SERVICE BULLETIN

ENGINE - FUEL AND CONTROL - REPLACE THE FUEL NOZZLE SUPPLY MANIFOLD ASSEMBLIES (FOR THE V2500-A1, V2522-A5, V2524-A5, V2527-A5, V2530-A5 AND V2533-A5 ONLY) AND REMOVE THE GASKET OPTION AND CHANGE THE INSTALLATION PROCEDURE (FOR ALL MODELS) - CATEGORY CODE 6 - MOD.ENG-73-0088

V2500-ENG-73-0088

Fig.1

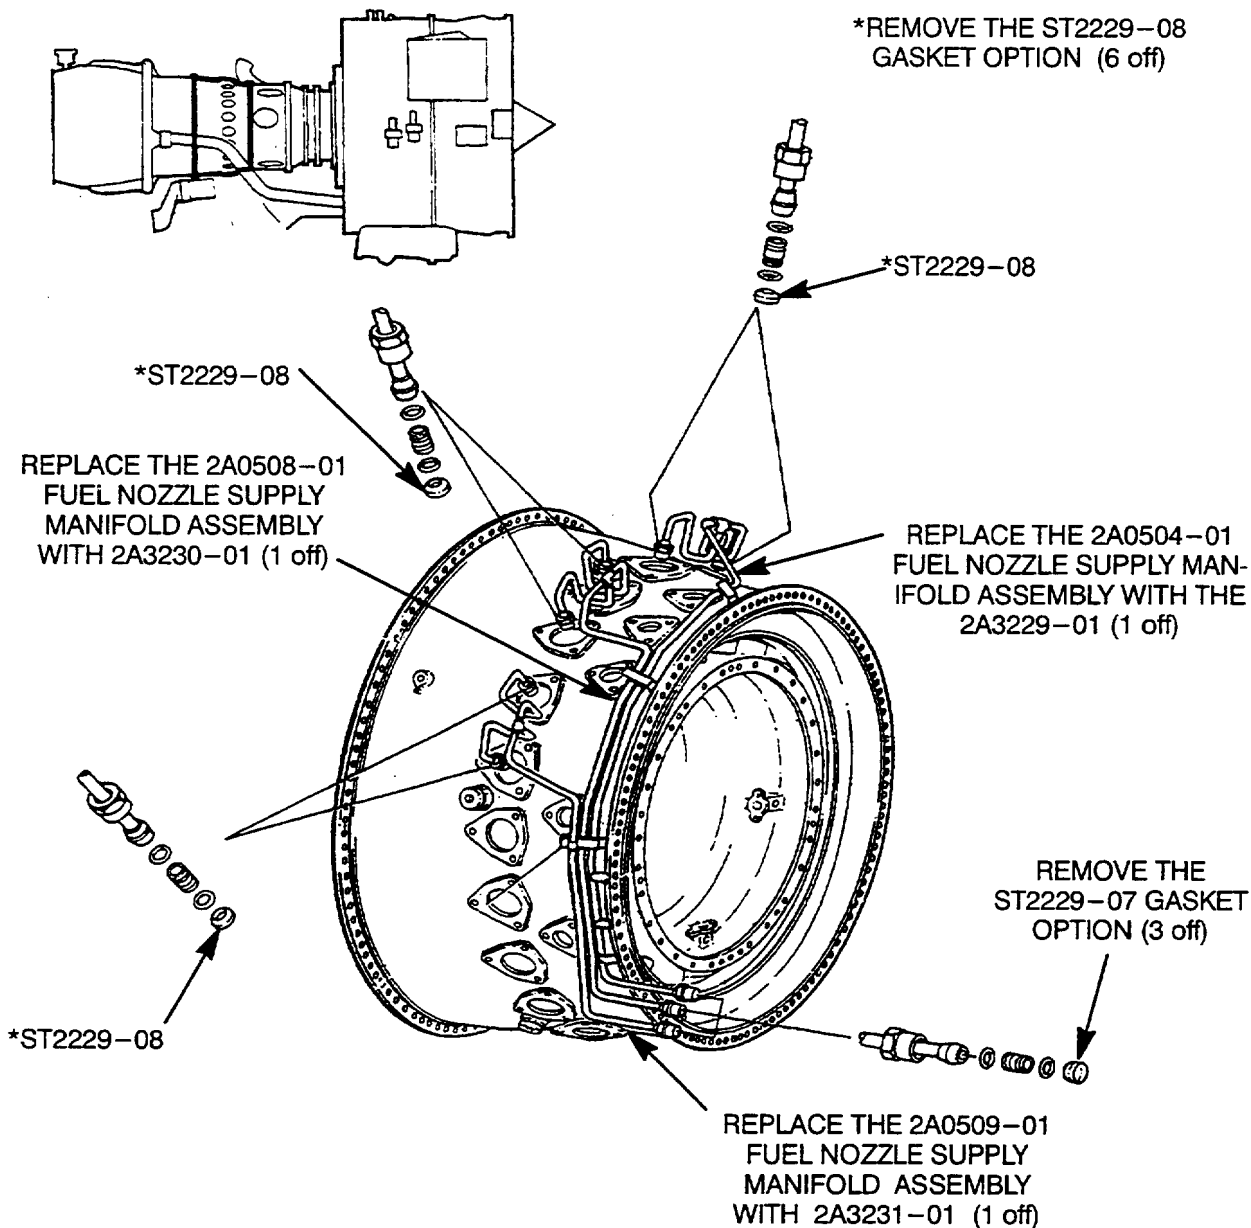
- (a) Apply CoMat 06-078 anti-galling compound in the areas shown by the procedure specified. See Reference (1), Control No./Task No. 70-38-27-380-501. See Figure 1 for applicable locations.

TREAT ENCLOSED AREA PER TEXT

TREATMENT OPTIONAL AND CAN BE INCOMPLETE

Fig.2

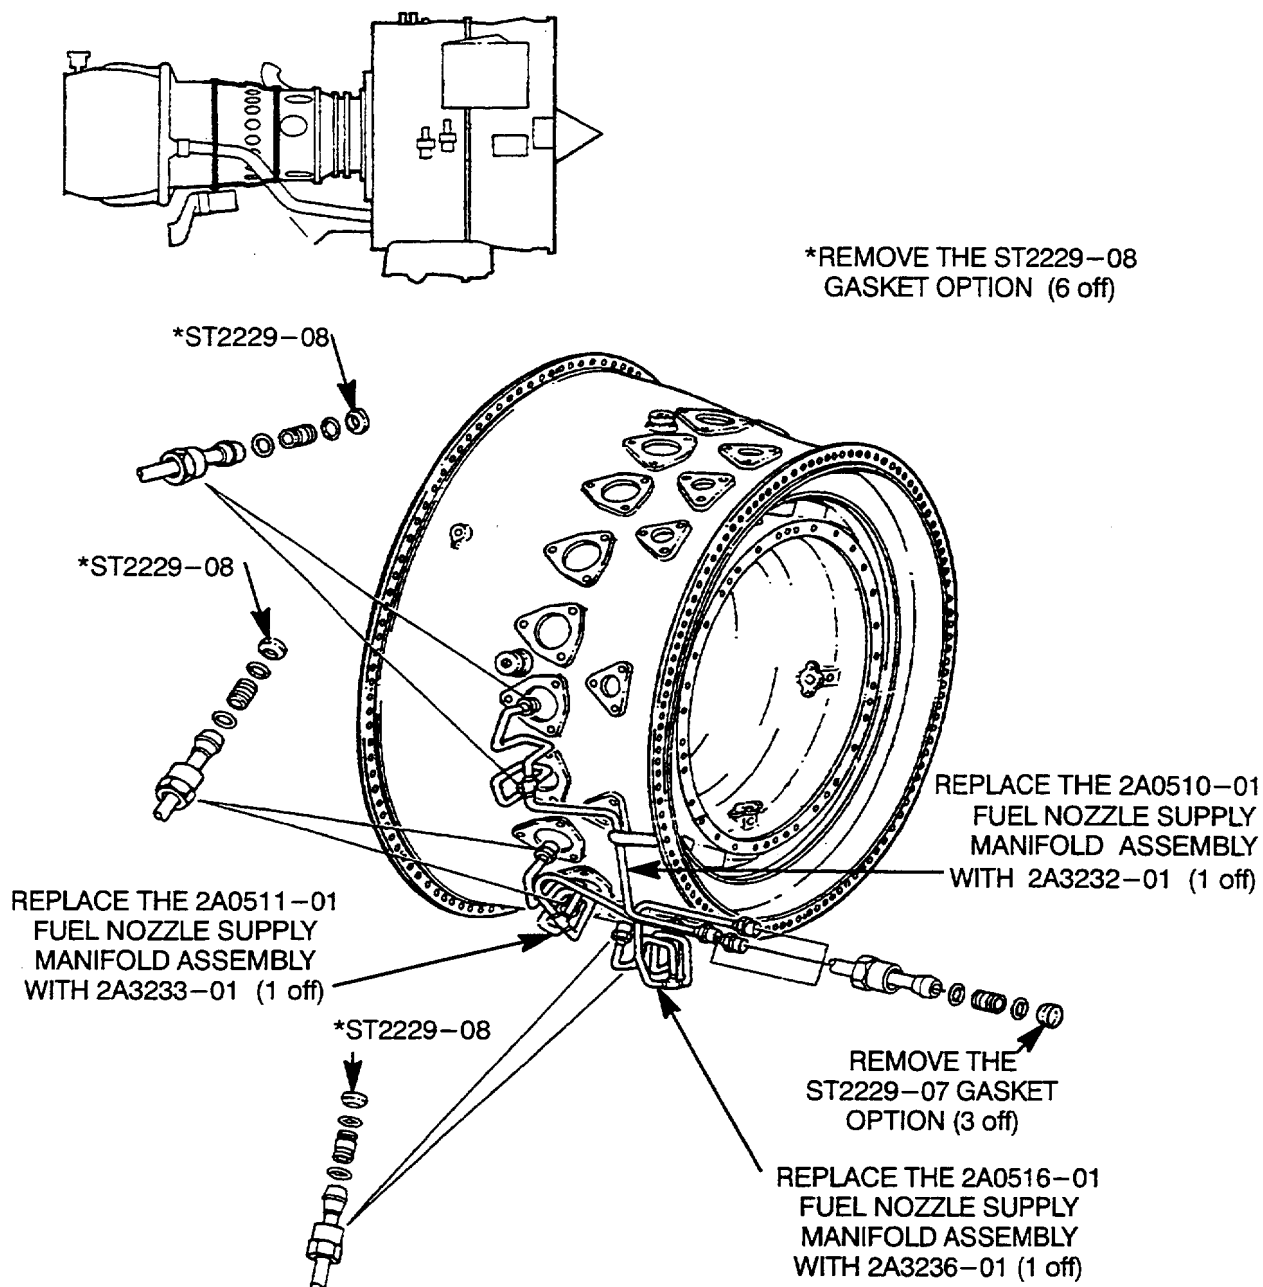
- (1) Install the new part number Fuel Nozzle Supply Manifold Assemblies by the procedure given in Reference (5), Chapter/Section 72-42-00, Assembly, except as follows:
- (a) Do not install the ST2229-08 Gasket Option (20 off) again at the locations specified in Figures 1 through 3. These parts will not be used with the new configuration.

- (b) Do not install the ST2229-07 Gasket Option (10 off) again at the locations specified in Figures 1 through 3. These parts will not be used with the new configuration.
- (c) Use CoMat 10-121 as a lubricant on the Transfer Tube Packings at the locations specified in Figure 2. See Reference (1), Control No./Task No. 70-64-02-640-501.

Modification of the Fuel Nozzle Supply Manifold
Fig.8 (Sheet 1)

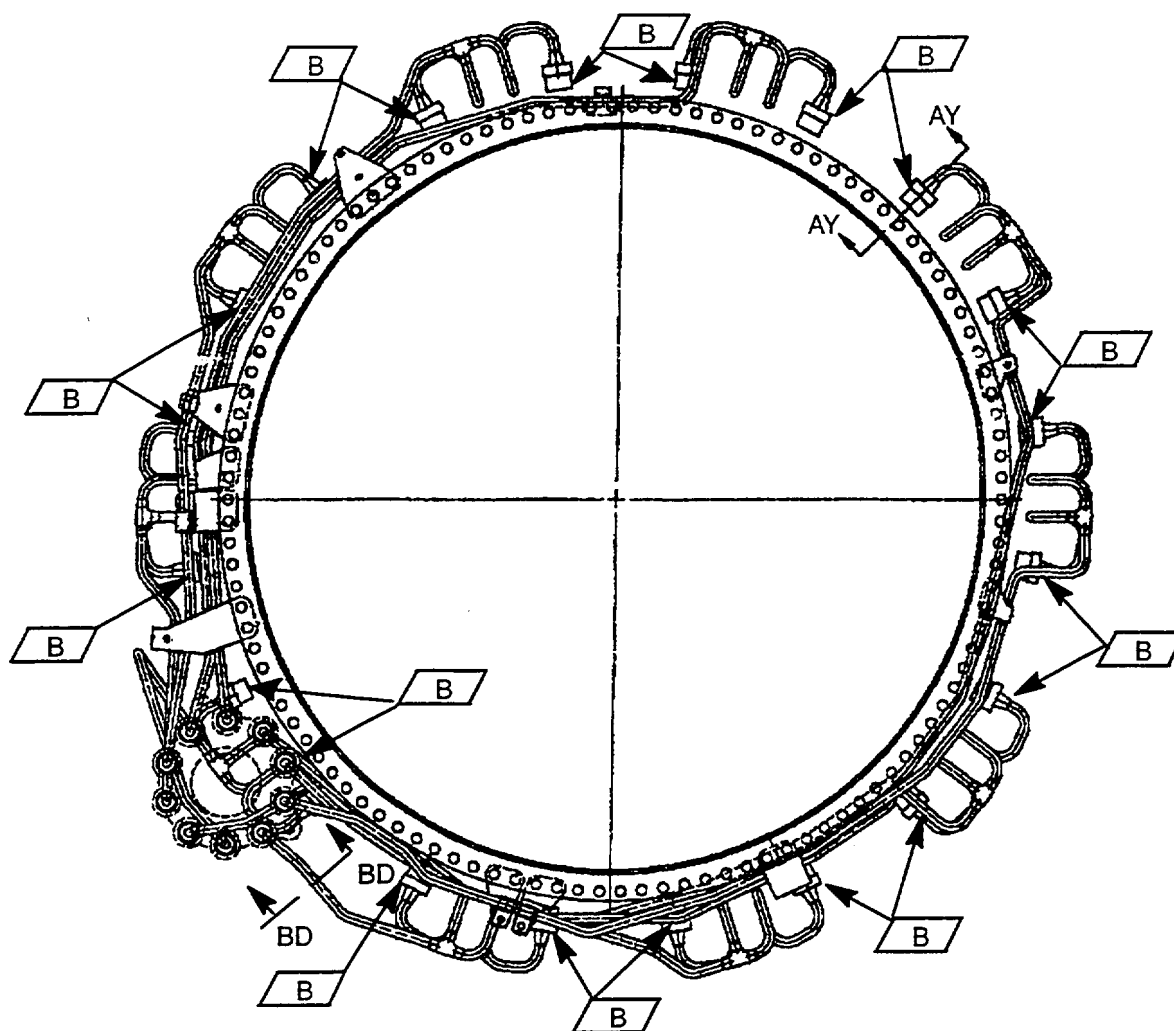
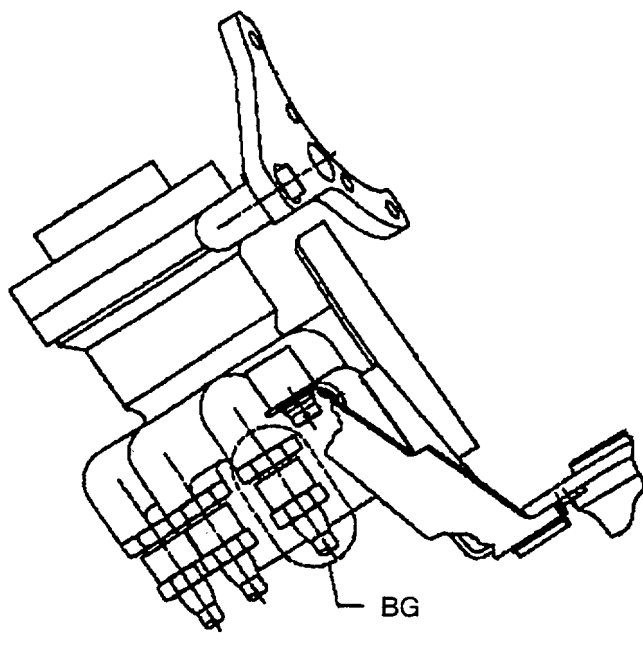
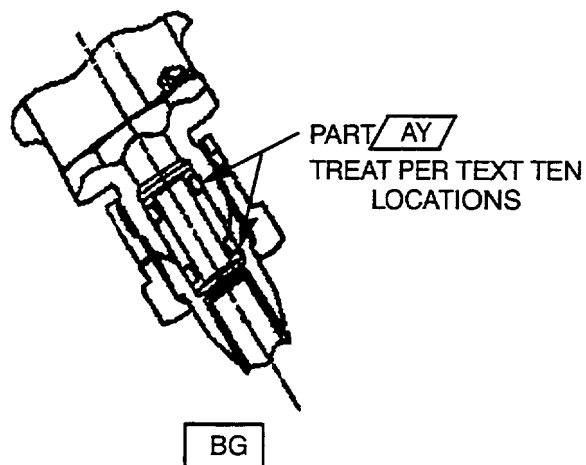
- (1) Install the Fuel Nozzle Supply Manifold Assemblies by the procedure given in Reference (6), Chapter/Section 72-42-00, Assembly, except as follows:
 - (a) Do not install the ST2229-08 Gasket Option (20 off) again at the locations specified in Figures 1 through 3. These parts will not be used with the new configuration.
 - (b) Do not install the ST2229-07 Gasket Option (10 off) again at the locations specified in Figures 1 through 3. These parts will not be used with the new configuration.
 - (c) Use CoMat 10-121 as a lubricant on the Transfer Tube Packings at the locations specified in Figure 8. See Reference (1), Control No./Task No. 70-64-02-640-501.

PART **AP** TREAT PER TEXT

SECTION AY – AY 20 PLACES
AT LOCATION **B**

NOTE: CoMat 10-121 replaces CoMat 10-041 at the locations specified. CoMat 10-041 is not used in the new configuration.

Family Tree (V2500-A1, V2522-A5, V2524-A5, V2527-A5, V2530-A5 and V2533-A5 Engines) -
Ref. Catalog Sequence No 73-11-41. Fig. 01 Items 060, 160, 260
Fig.9

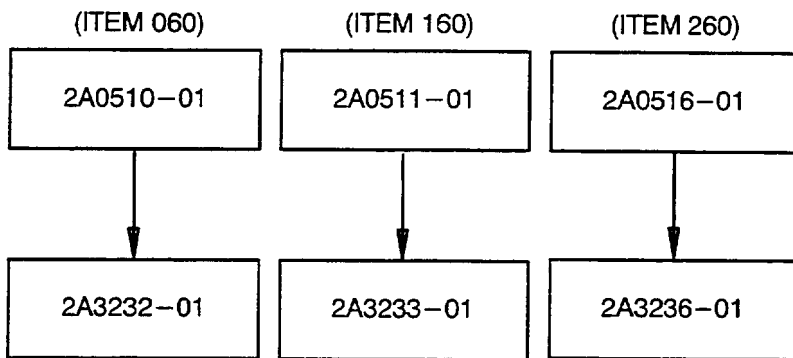
- | (b) Mark the new part number adjacent to the existing part number. Use the vibration peen method. | Existing | New Part Number |

| | 2A0504-01 | 2A3229-01 |
| | 2A0508-01 | 2A3230-01 |
| | 2A0509-01 | 2A3231-01 |
